PRODUCT CHANGE NOTIFICATION

PCN No.: PCN-202510-003	**PCN Doc No.:** EC-20251021-PCN-03	**Date Issued:**	10/21/2025
Part Number or Series: PH1RB-XX-UA		**PCN Effective Date:**	10/21/2025
Customer: (If applicable)		**P/O No.: (If applicable)**	Not affected
Type of Change:	■ Mfg location Change / Qualification / Country of Origin (COO) ■ Design Change / Data Sheet Spec Change	**Last Time Buy Date:**	Not affected
Traceability Marking/Date code: No change		**Last Time Ship Date:**	Not affected
Replacement Part Number: PH1RB-XX-UA-HT-Y		**Sample Availability Date:**	Not affected

China Part

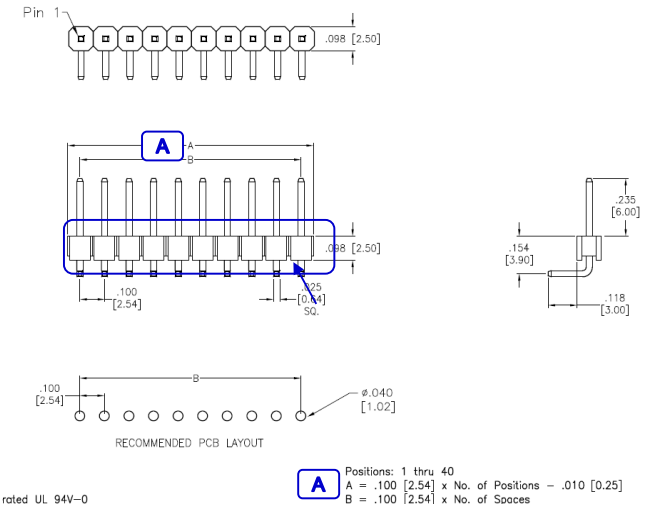
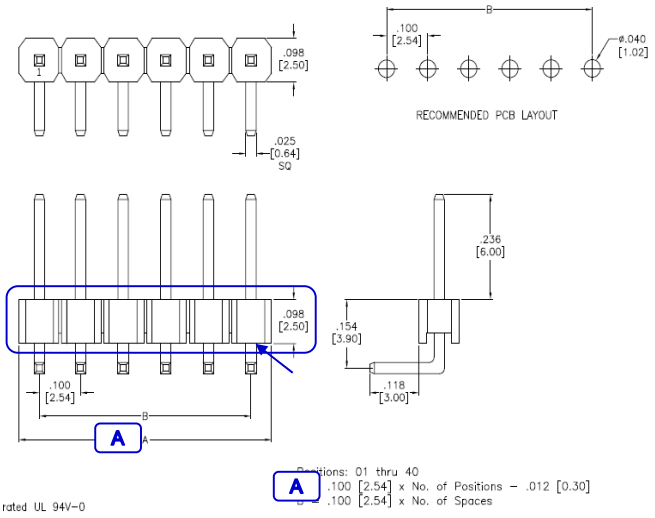
Impact of Change: P/N change, There are slight differences in appearance and size;	**Original COO parts still available:** Yes ☑ No ☐

Before the change:
1、Appearance ~ As shown in the above picture;
2、Size:
A) A=.100[2.54]xNo. of Positions - .010 [0.25]

After the change:
1、Appearance ~ As shown in the above picture;
2、Size:
A) A=.100[2.54]xNo.of Positions - .012 [0.30]
